M E M O R A N D U M

RE: Floodplain Construction/Reclamation along White Rock Creek -  
"The Woods" Subdivision

Re: "The Woods" Subdivision  
Addison, Texas

Re: "The Woods" Subdivision, Addison, Tx  
Huitt-Zollars Project No. 1-0438-01

BLOCK A/8172

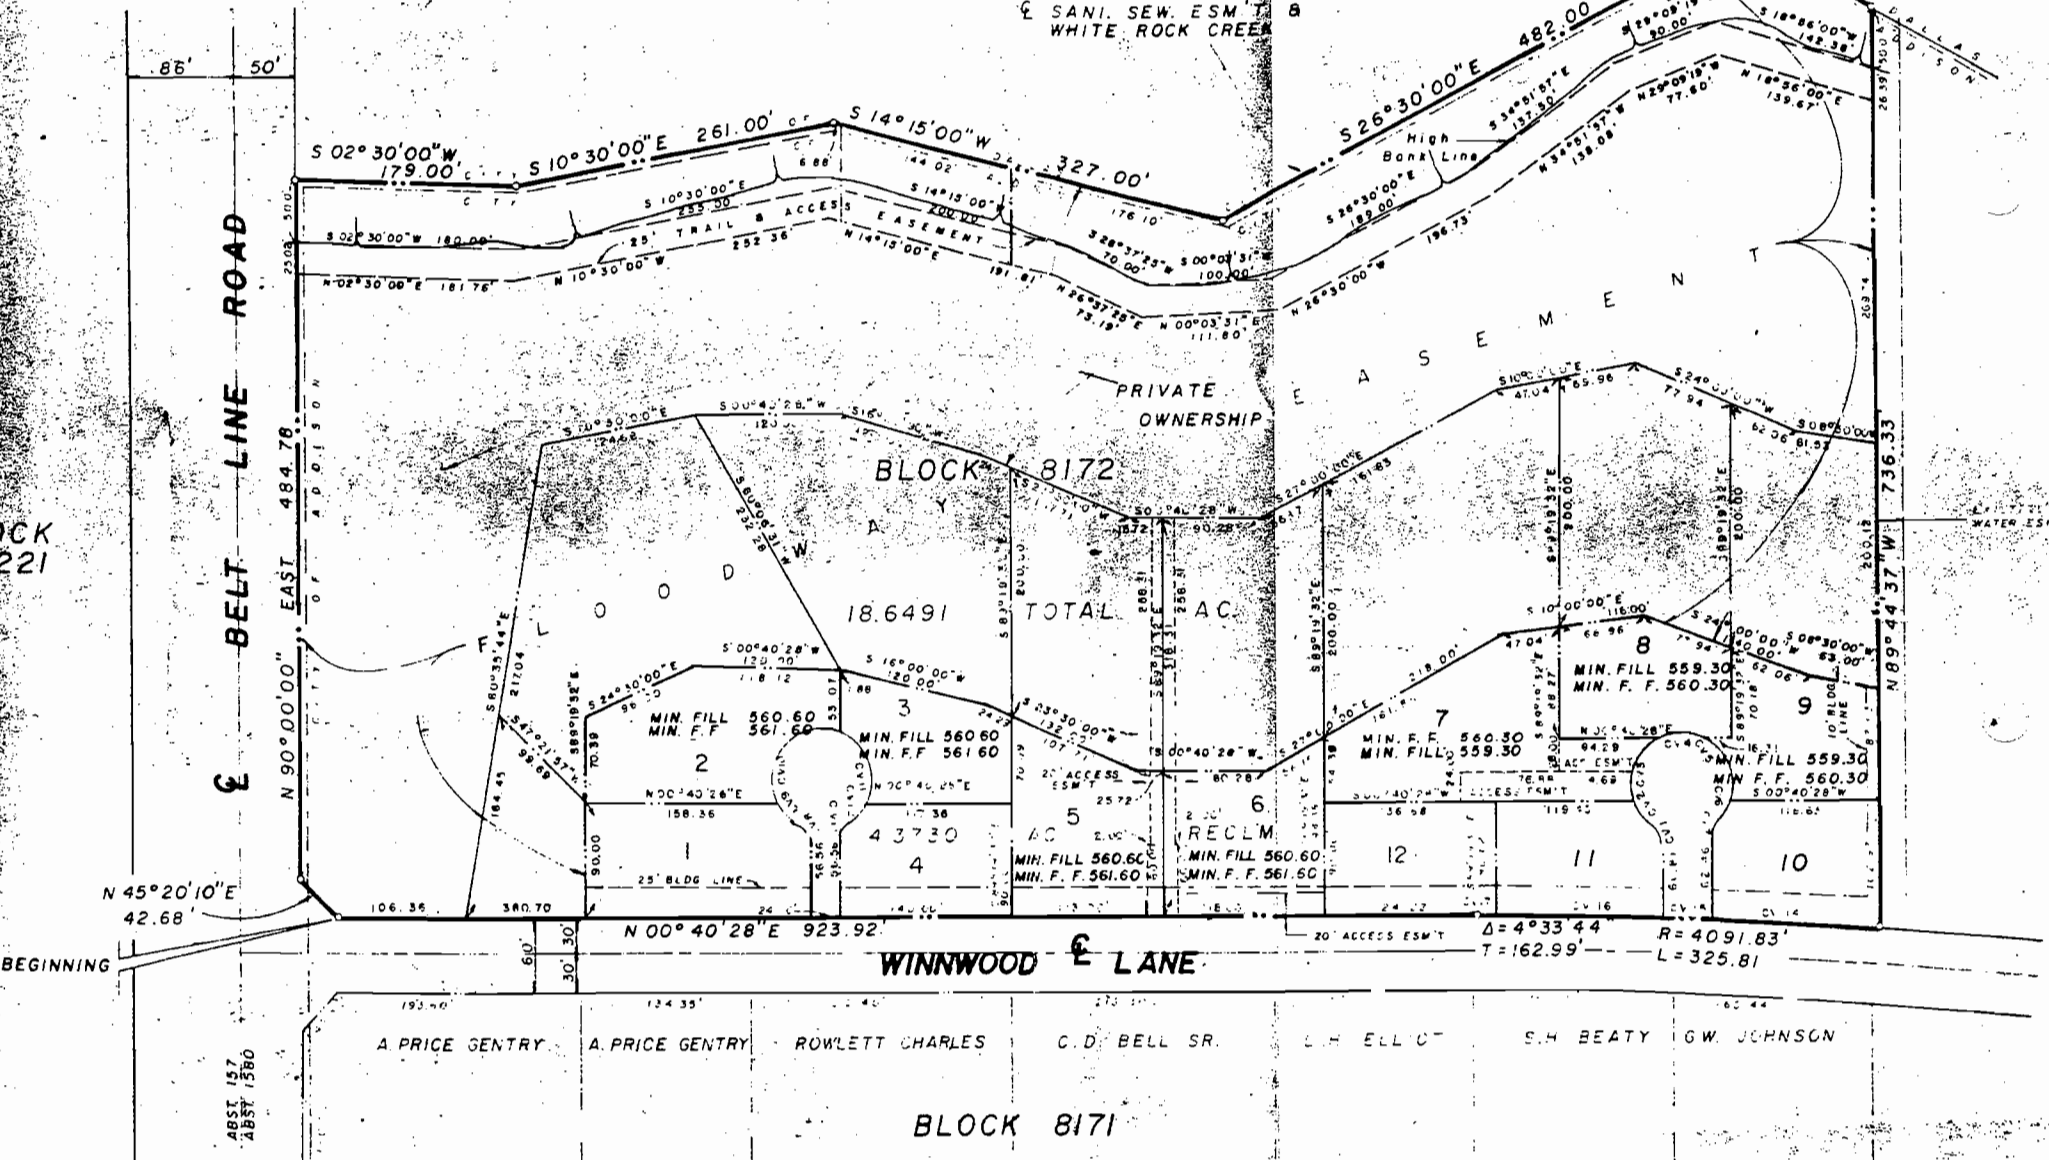
We recommend that the building permit be issued subject to the following: 1) the final slope on Lot 6 be prepared to a 6:1 slope and, 2) the existing slope of 2.5:1 on Lots 1 and 8 be prepared to a final slope of 3:1. Before final approval of any buildings or homes, the grading of these lots should conform to the slopes just mentioned.

We must, however, point out that the fill on Lot 6 exceeds the maximum 6:1 slope in a localized area. But the As-Built 5:1 slope in that location will not have any adverse effect on the hydraulic conditions in flood stage. In addition, the maximum 3:1 slope permitted along the rear of Lots 1 & 8, exists as 2.5:1 in the As-Built condition. Again, hydraulically this will have no effect but it is our judgement that from an erosion point of view, this could create problems in the future if the soil is not adequately protected.

In addition, we recommend that the developer have Huitt-Zollars, Inc. certify that the final grading on the remaining lots in "The Woods" subdivision conforms to the flood study which was prepared for this project. This letter of certification should be received by the Town of Addison or Ginn, Inc. prior to issuing approval of final inspection.
